SOUTHERN GULF ISLANDS HARBOURS COMMISSION
Notice of Meeting on **Friday, October 9, 2026 at 9:30 am**
Saanich Peninsula Wastewater Treatment Plant Meeting Room,
9055 Mainwaring Road, North Saanich, BC

**REPORT TO SOUTHERN GULF ISLANDS HARBOURS COMMISSION
MEETING OF FRIDAY, OCTOBER 9, 2026**

SUBJECT **Southern Gulf Islands Harbours Projects and Operations Update – October 2026**

Southern Gulf Islands Harbours DOCK INSPECTION REPORT

Montague Harbour Dock Arrangement

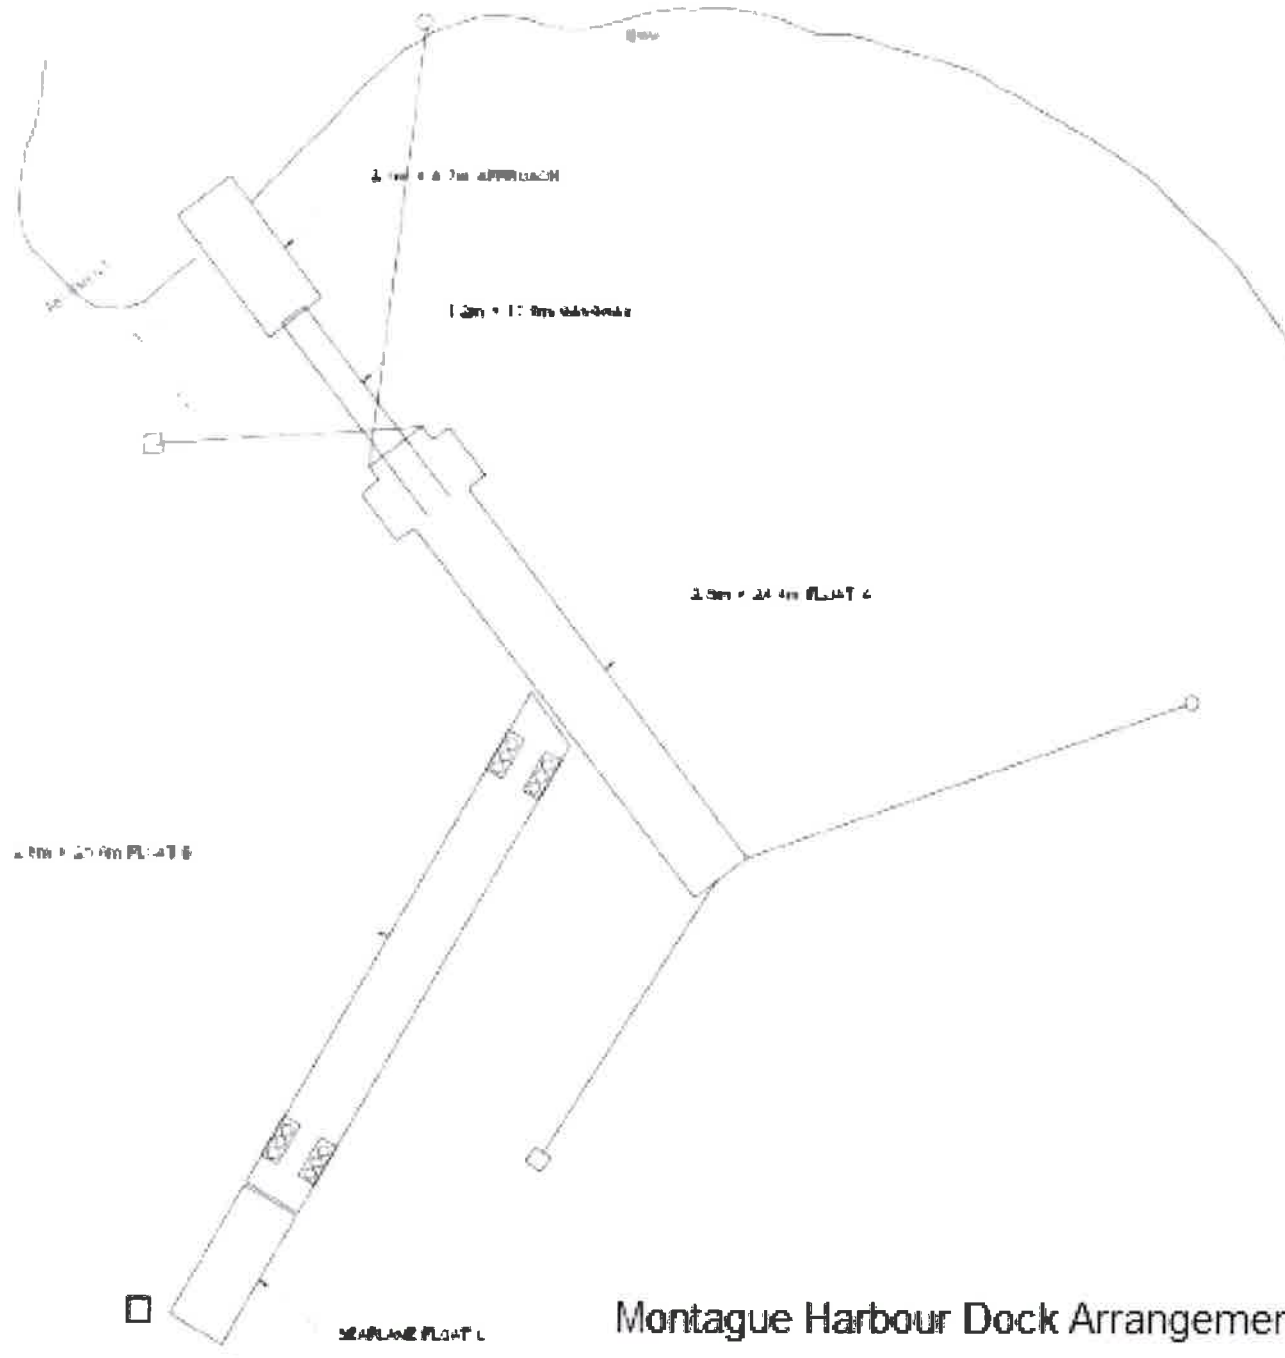
COMMENTS/INSTRUCTIONS	> Loose deck boards require re-nailing. > Float A life ring requires a new grab line. > Monitor the flotation at the end of float A. > Monitor the wear on the connecting hardware for floats A & B.
------------------------------	--

Hope Bay Dock Arrangement

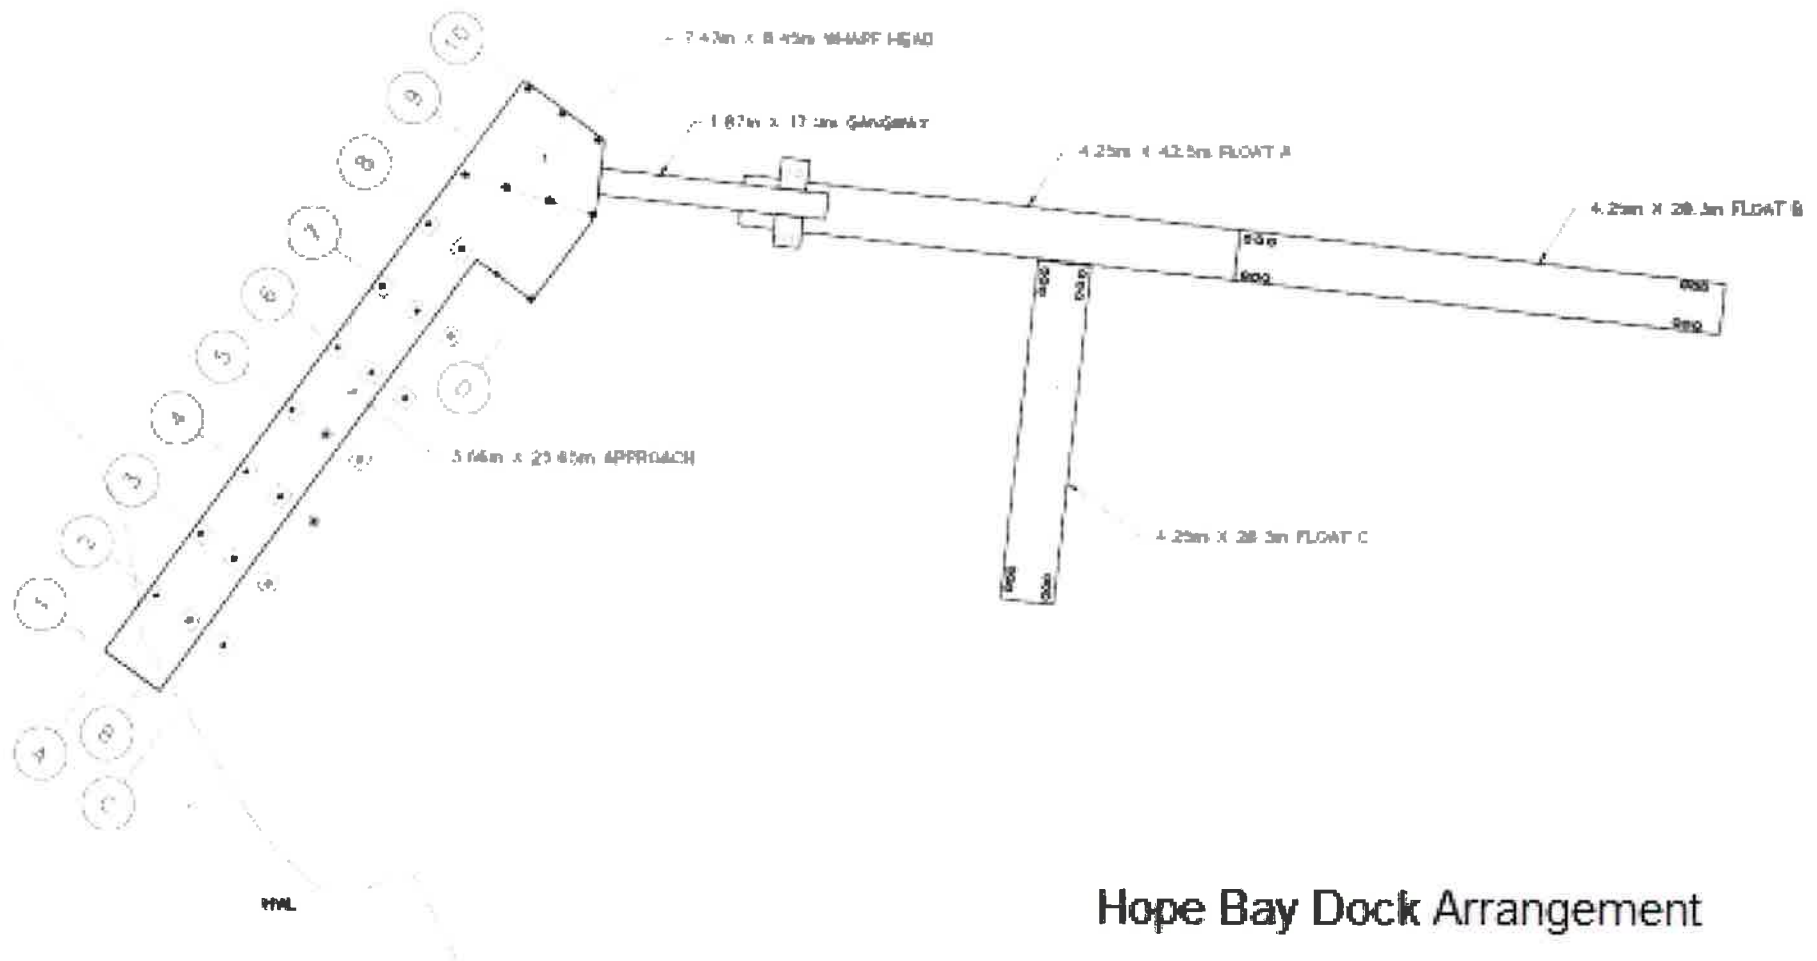
COMMENTS/INSTRUCTIONS	> Paint (blue) is required for the light standard.
	> Painting the railings would help improve the overall look of this facility.
	> Replacing the older wood decking on the gangway with Mini Mesh decking is recommended.
	> Refastening the metal fencing on the approach is required along the bottom edge or replace with new fencing.

Horton Bay Dock Arrangement

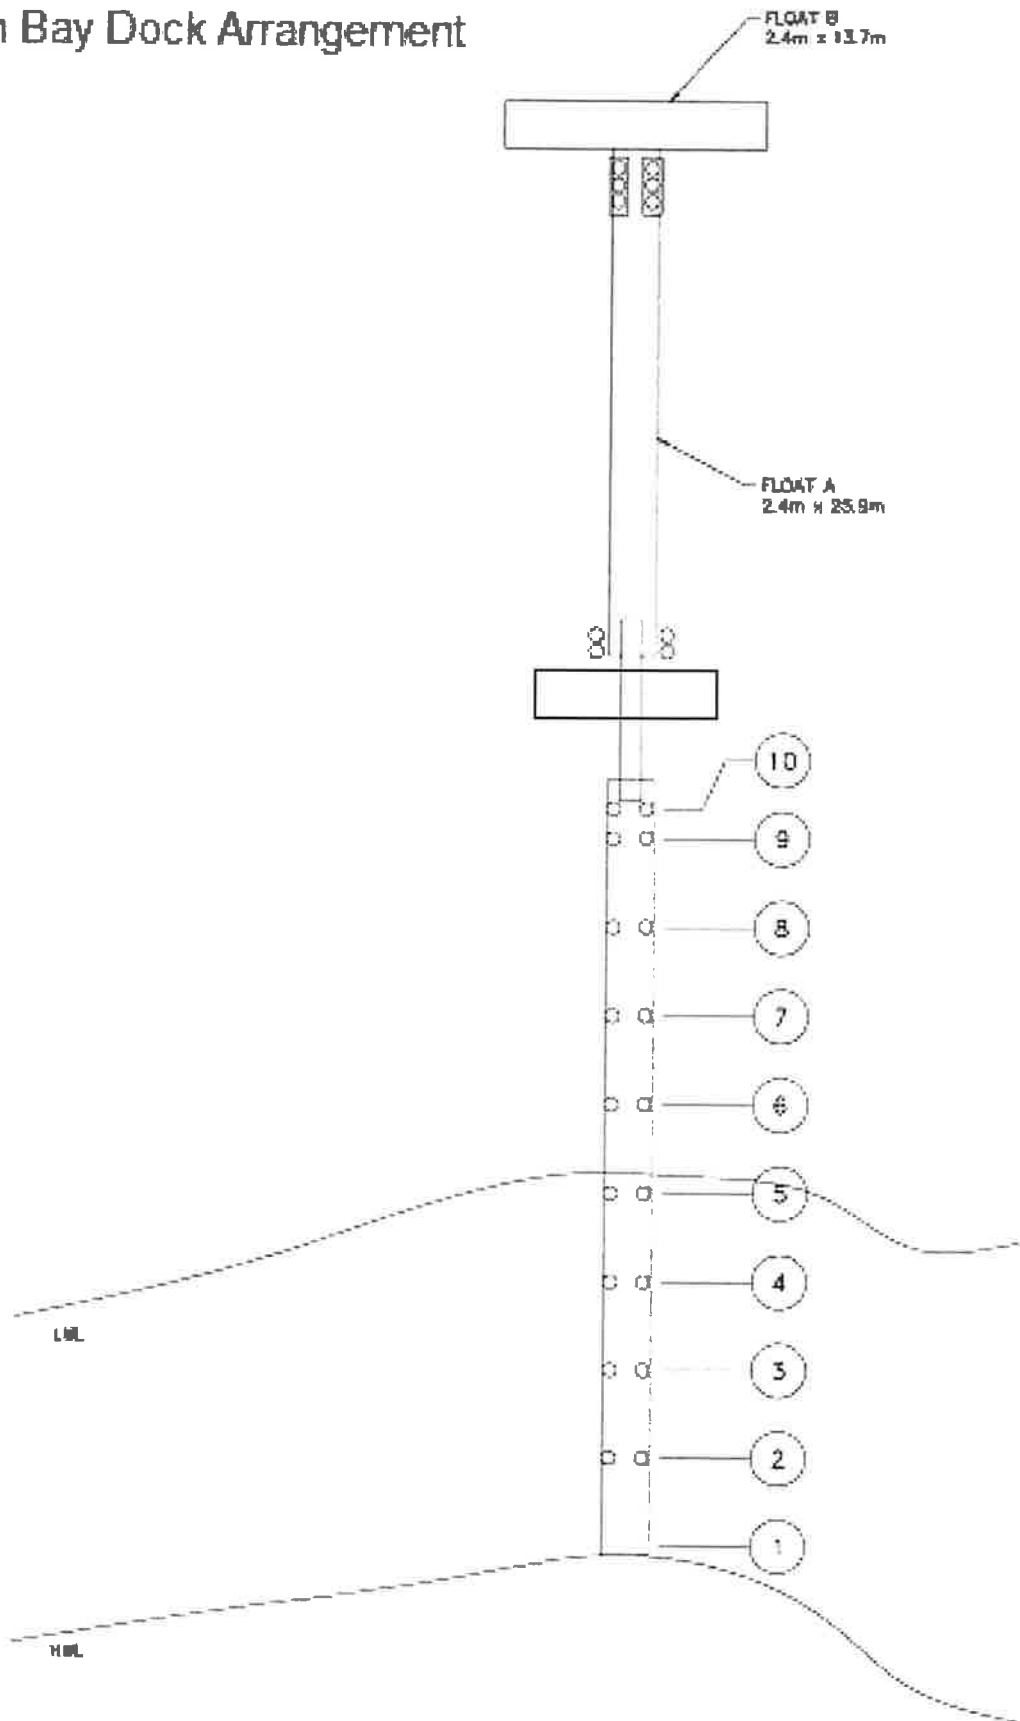
COMMENTS/INSTRUCTIONS	> The electrical service is old and requires inspection.
------------------------------	--

Miners Bay Dock Arrangement

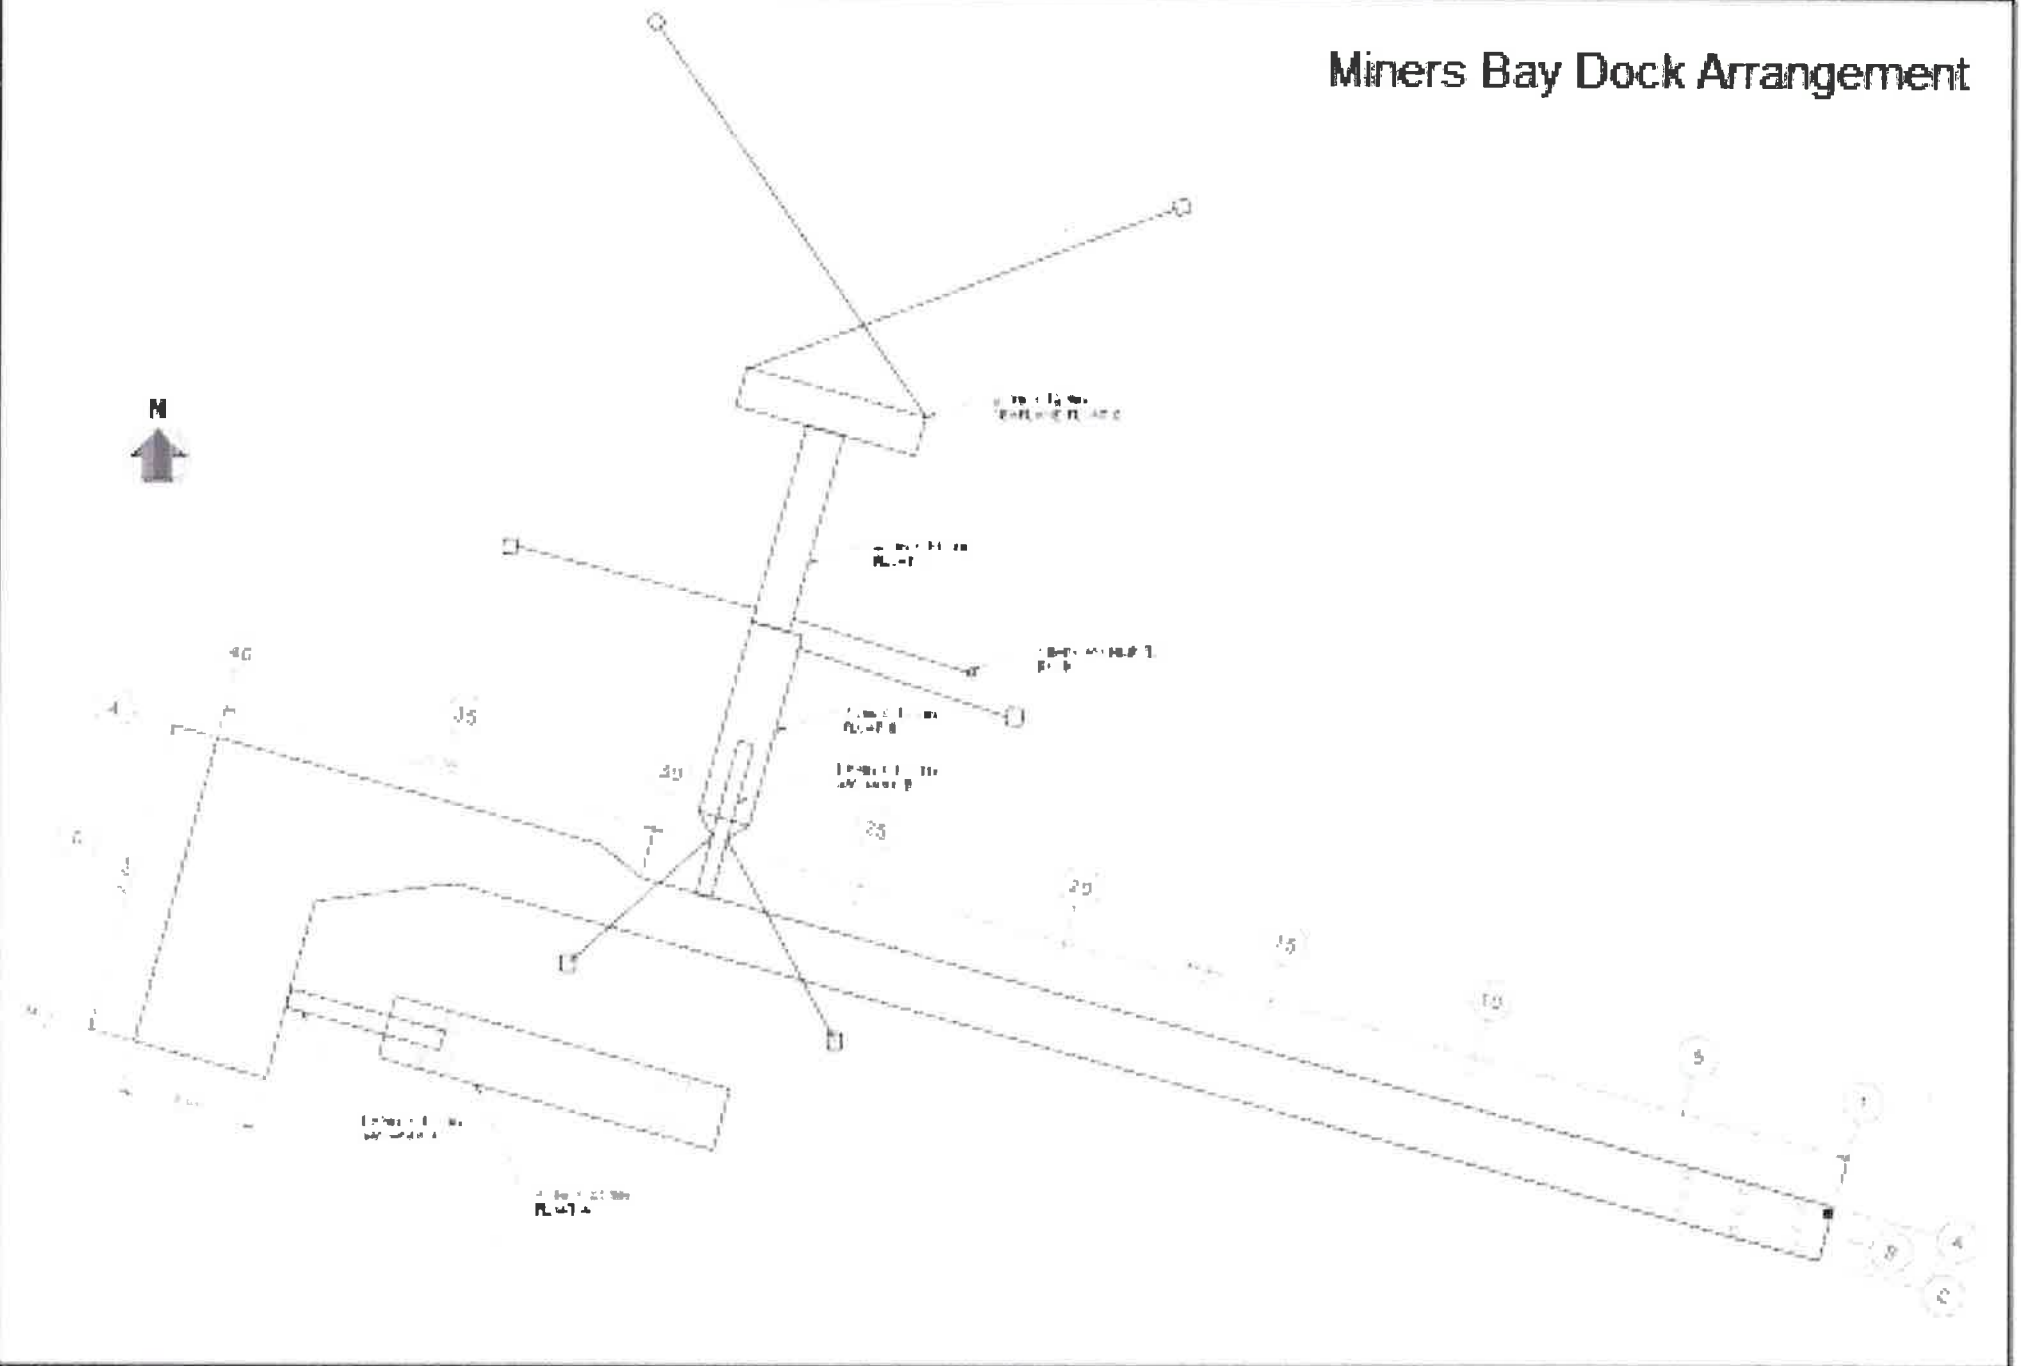
COMMENTS/INSTRUCTIONS	> Replace the 4 rotten deck boards on the approach near the entrance to Float B. > Replace UHMW skid shoe or install runners on gangway (Float A) bottom apron. > Replace bull rails on Float A (worn/broken/missing and loose rail bolts). > Safety ladders require cleaning on Float A, repair ladder on float B (short term side). > Monitor the developing rot on the approach, wharfhead and wear of the wood piles of float A. > Decking on Float A is loose and refastening is recommended.
------------------------------	--

Port Washington Dock Arrangement

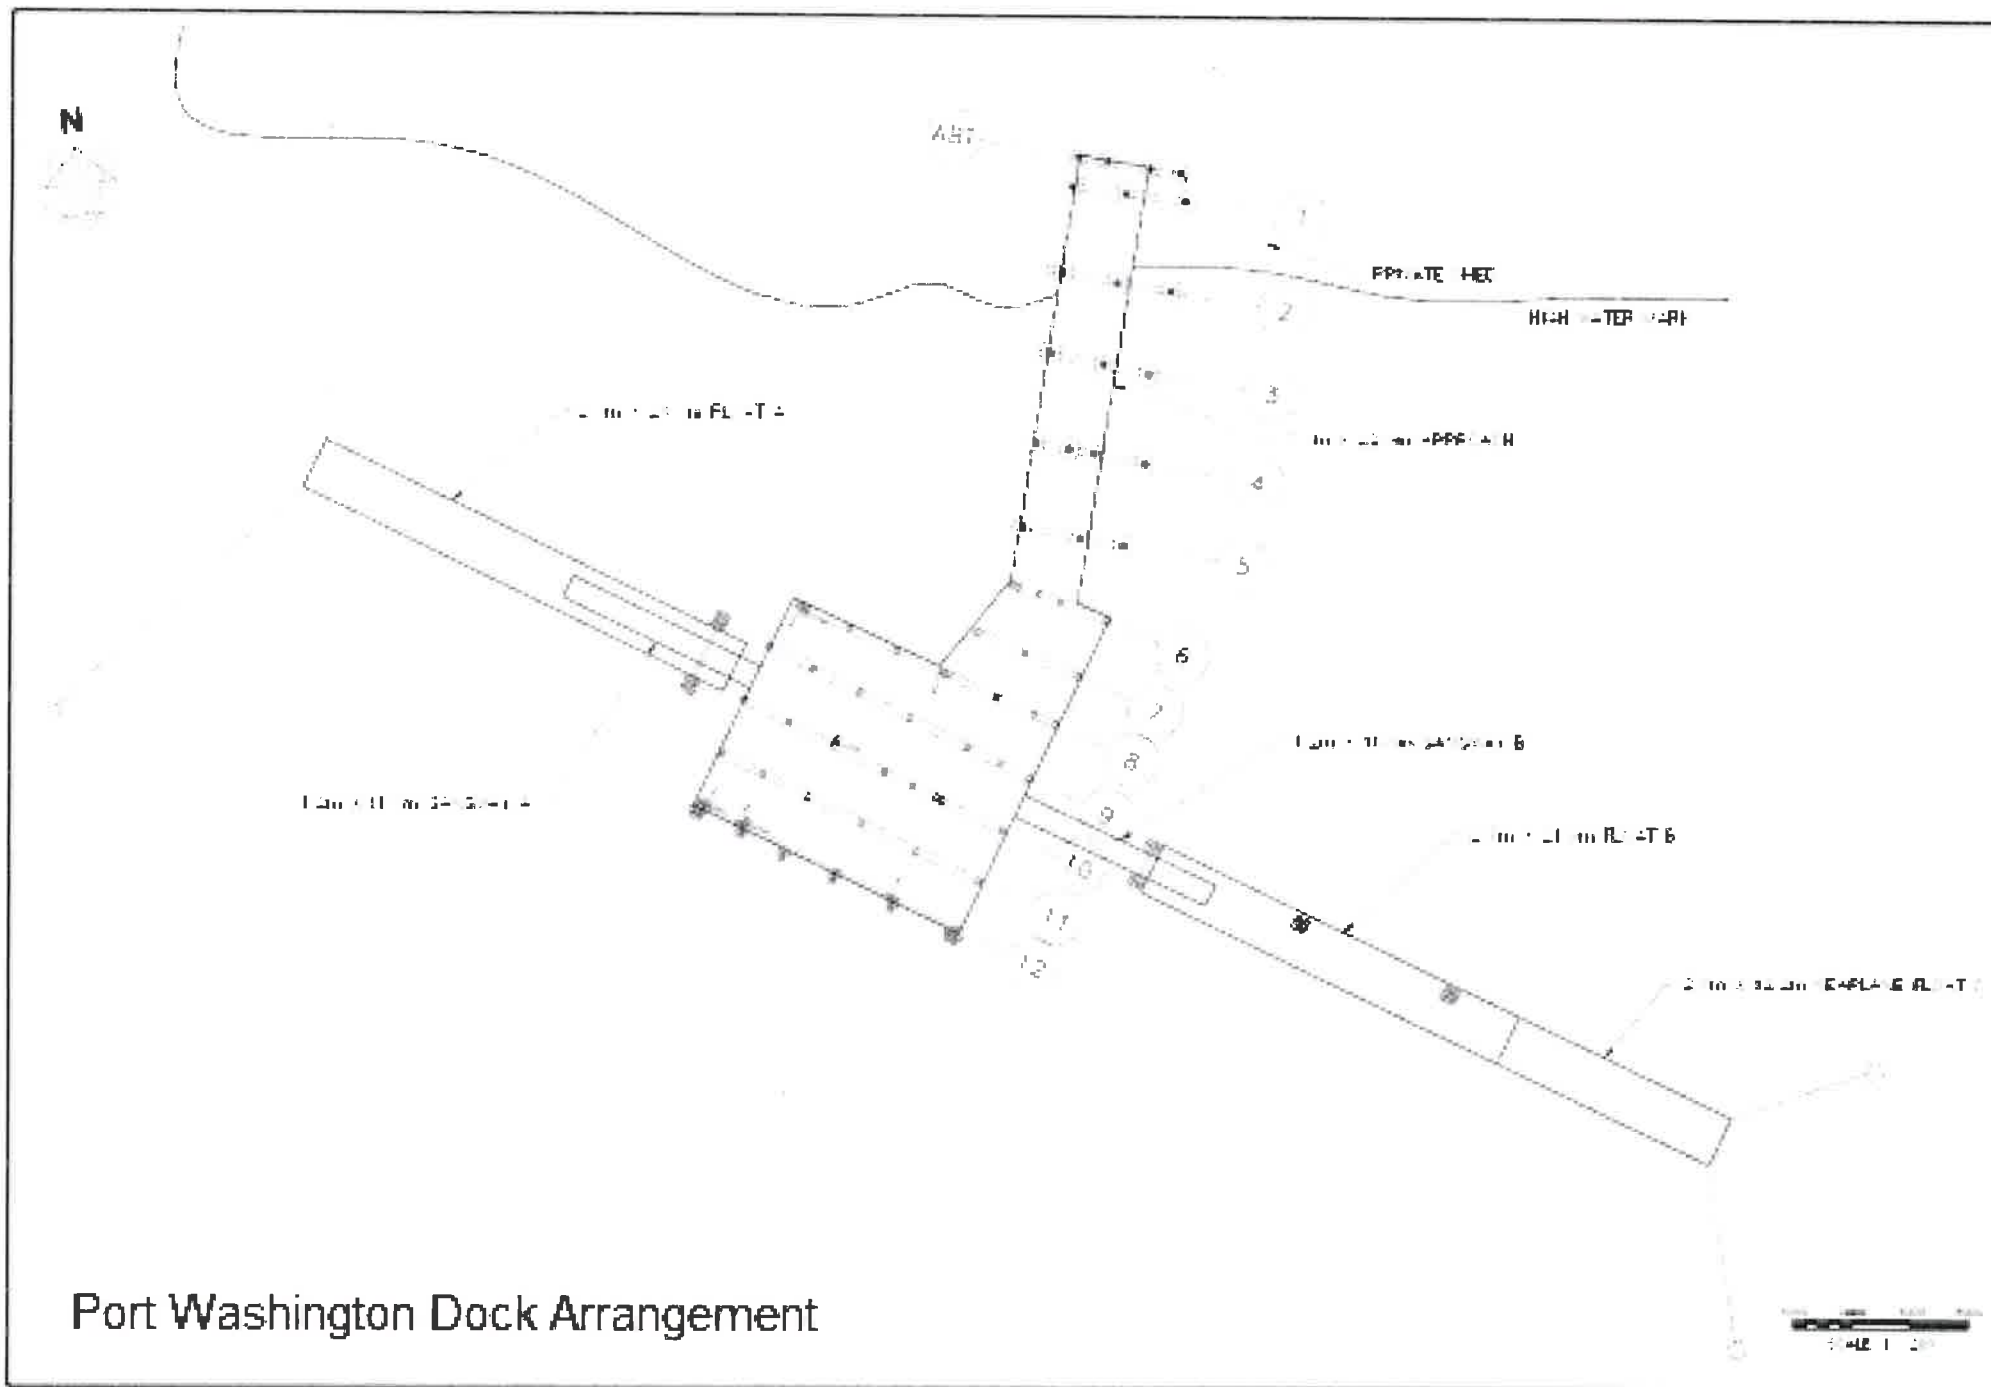
COMMENTS/INSTRUCTIONS	> The gangway roller on B float requires replacement. > A pillow block is required for the roller on gangway B. > Replacing the decking on the 2 gangways with mini mesh decking is recommended. > UHMW runners or a shoe are recommended for gangway A's bottom apron.
------------------------------	---
